**AGENDA
CITY OF CEDAR FALLS, IOWA
PLANNING AND ZONING COMMISSION MEETING
WEDNESDAY, AUGUST 14, 2024
5:30 PM AT CITY HALL, 220 CLAY STREET**

2. **HWY-1 District Site Plan for Golden China restaurant at 1150 Brandilynn Blvd. (Case #SP24-004)**
Petitioners: Darren Fang, LLC, owner; Dan Levi, Levi Architecture; Monica Smith, Robinson Engineering
Previous discussion: none
Recommendation: *Denial*
P&Z Action: *Discuss and make a recommendation to approve, deny, or continue the discussion to a future meeting to give time for the applicant to make modifications.*

TO: Planning and Zoning Commission
FROM: Thom Weintraut, AICP, Planner III
Ben Claypool, Civil Engineer II, PhD., PE.
DATE: August 14, 2024
SUBJECT: HWY-1 District Site Plan for Golden China

REQUEST: HWY-1 District Site plan approval for construction of a new restaurant, Golden China, on Lot 4 of Pinnacle Prairie Commercial South, Phase V (Case # SP24-004)

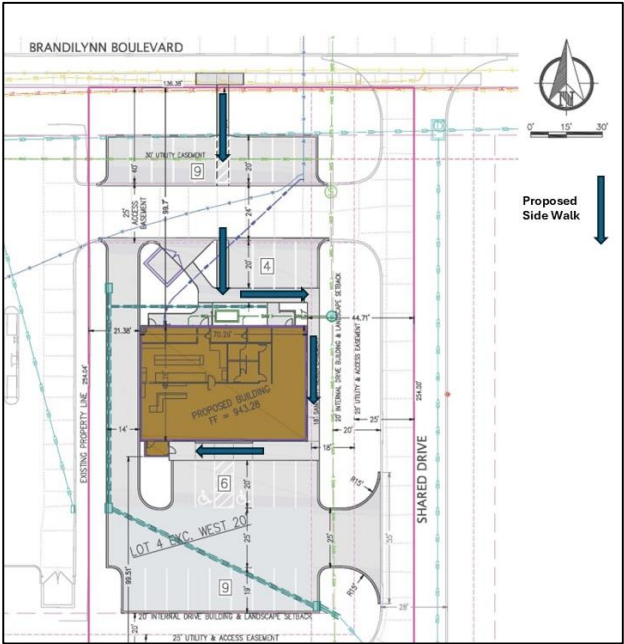
This property only has one street frontage, Brandilynn Boulevard. However, the site is designed so the back side of the building is oriented toward the public street. As shown below, the façade facing Brandilynn is clearly the service side of the building meant for access for employees only and is the location of the refuse enclosure. There is no customer entrance on this side, nor is a customer entrance visible from the public street. This side of the building is largely a blank façade with no design elements typical of a front façade, such as storefront windows and customer entrance features.

The proposed orientation of the building poses a particular challenge for pedestrian and bicycle access to the site. The sidewalk connection from Brandilynn Boulevard to the entrance of the building, leads the public to a blank wall on the rear of the building. The pedestrians are then required to walk along the rear of the building to the east side, turn and go south along the building’s eastside to the sidewalk on the south side the building, and turn west and walk to the opposite end of the building to the public entrance on the southwest corner of

the building. There are no sidewalks along the private shared drive, so there is no direct or visible pedestrian access to the restaurant.

If the building was rotated 180 degrees, the main entrance would face Brandilynn Boulevard, and the public entrance would be located to address both Brandilynn Boulevard and the north-south access drive. The sidewalk connection could be location parallel to the access drive and create a more inviting public entrance to the building by providing a direct connection from the sidewalk along Brandilynn Boulevard to the main entrance. This change would not only make pedestrian access to the building more direct and easier it would provide a more welcoming and appealing appearance to pedestrians and the motoring public.

The orientation of the building with the back side of the building facing the public street does not meet the intent of the HWY-1 District. The orientation presents the less attractive aspects of the building and site within public view, including a blank façade, service entrance, and dumpster area. The pedestrian connection from the public sidewalk along Brandilynn leads to a service entrance rather than to the public entrance to the restaurant. In addition, the orientation of the building does not meet the Pinnacle Prairie Design Guidelines which require the primary façade of buildings to be oriented toward the street. Staff recommends re-orienting the building to face the public street, similar to other buildings in the area.

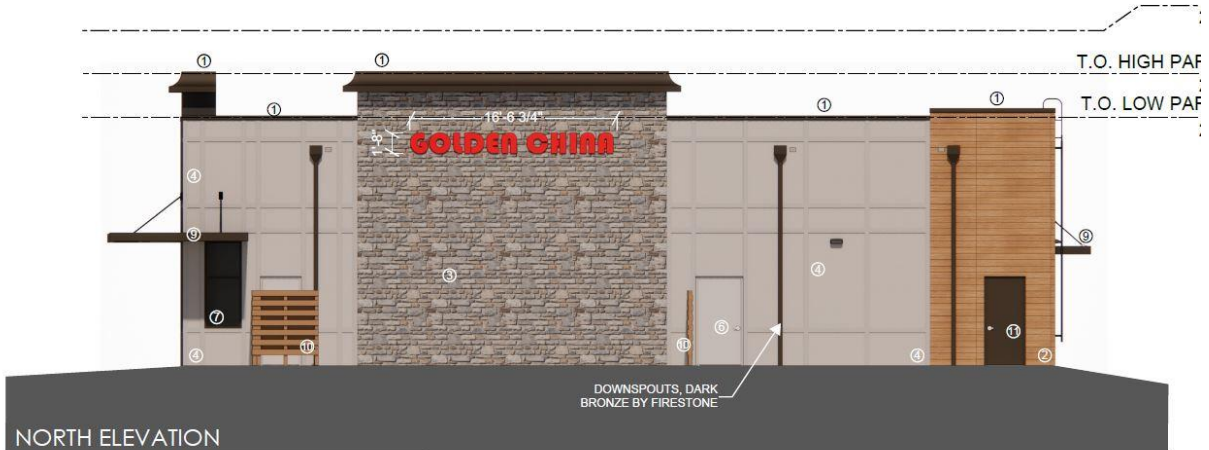
As shown above the street-facing façade has few windows and doors, so does not have a pattern discernible to viewers and is not consistent with other buildings in the area. On the south, west, and east-facing elevations, the placement of windows and board and batten siding create a strong vertical rhythm, while the use of the canopy on these two façades provides horizontal relief. The brackets for the awning introduce an additional rhythm to these elevations. The windows are well-distributed across the three facades that do not front of Brandilynn Boulevard. The Brandilynn Boulevard side of the building, because it is the service entrance, does not provide strong horizontal or vertical rhythm that come with the use of windows and doors with lights.

In summary, the proposed restaurant has a high quality of design and materials; however, because of the building's orientation with the "rear" facing the street, the street façade is not compatible with the other three buildings. Staff finds the architectural standards of the HWY-1 Zone are not met.

LA.1
 7/25/2024
 SUBMITTAL 3

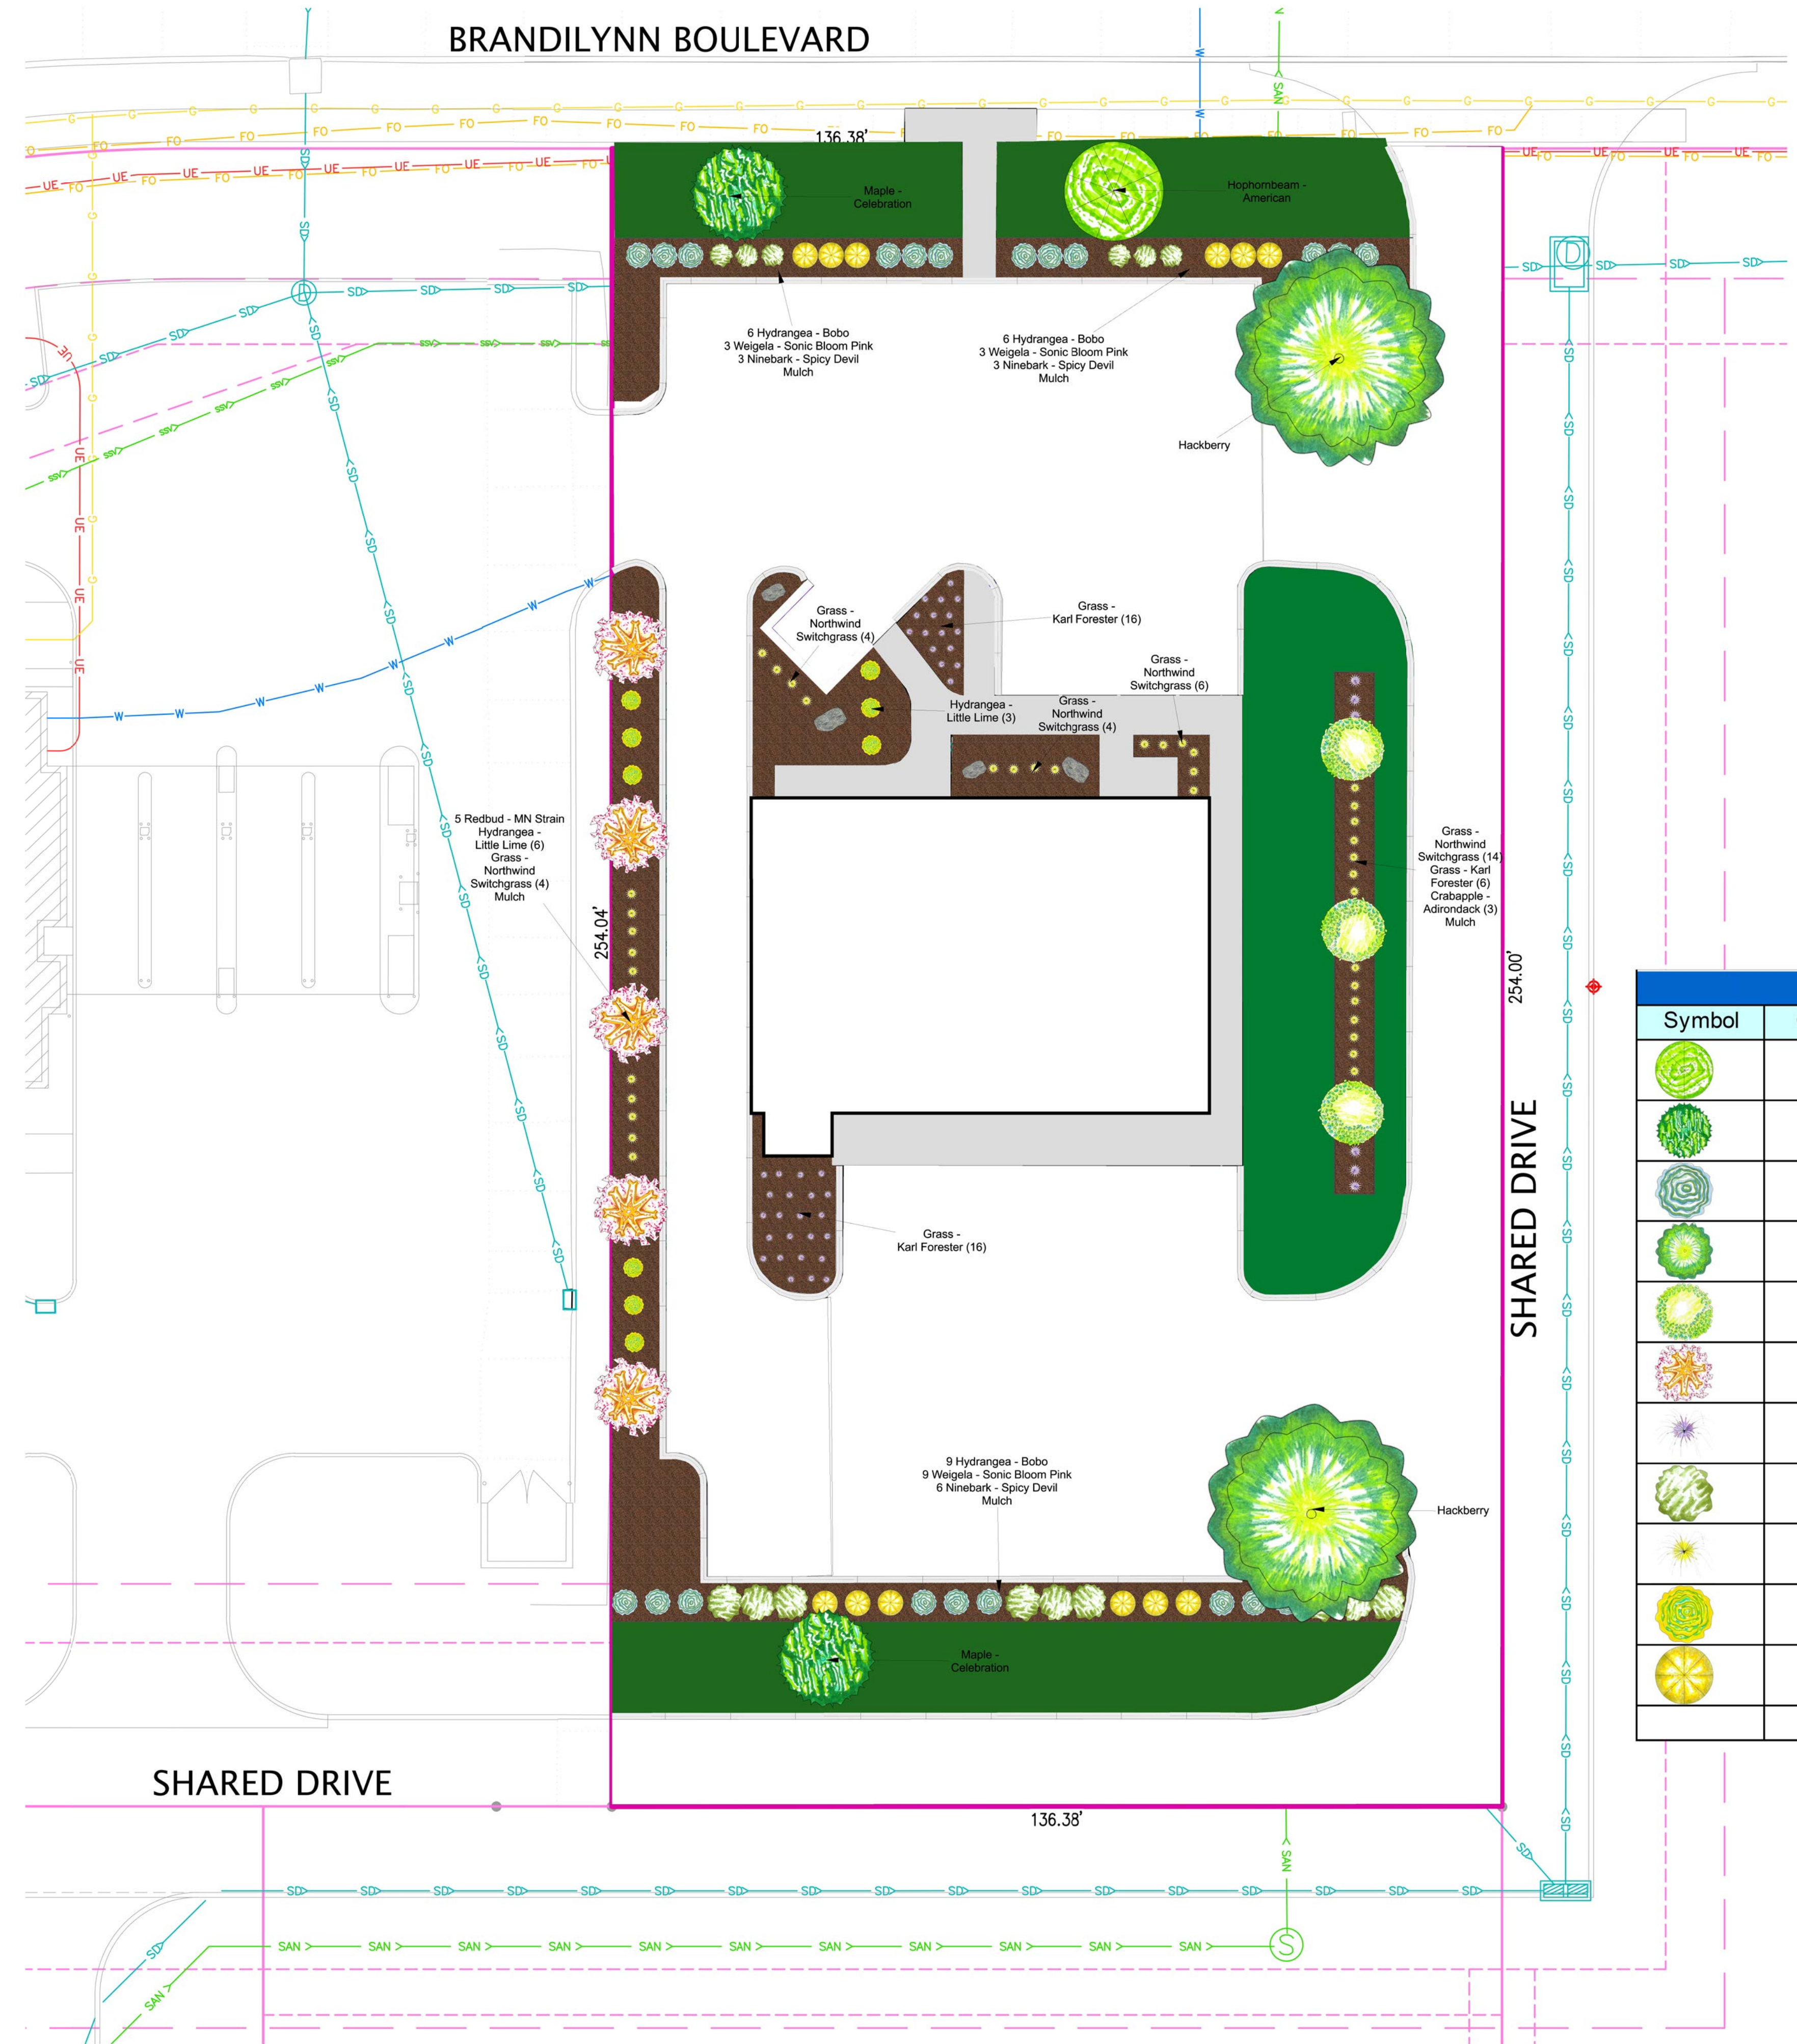
The total required site landscaping points are 681 points for the site and 320 points for street trees. The site plan shows the points for the street trees has been met and the total points for the site as 694 points; however, the landscape plan incorrectly identified the points for a 3" caliper Common Hackberry as 40 points and all 2 gallon size shrubs as 2 points. A 3" caliper Hackberry is worth 90 points, and 2 gallon shrubs are worth 5 points thus the total points landscape points equal 920 points and so the site exceeds the requirement by 239 points. Planting point details can be seen in the attached landscaping plan for review.

The landscaping plan shows trees and other landscaping features in the right of way or utility easements. Removal and replacement of the trees or any other landscaping including monument signs located within these areas that may be disturbed by utility maintenance, repair, or replacement is the responsibility of the property owner.
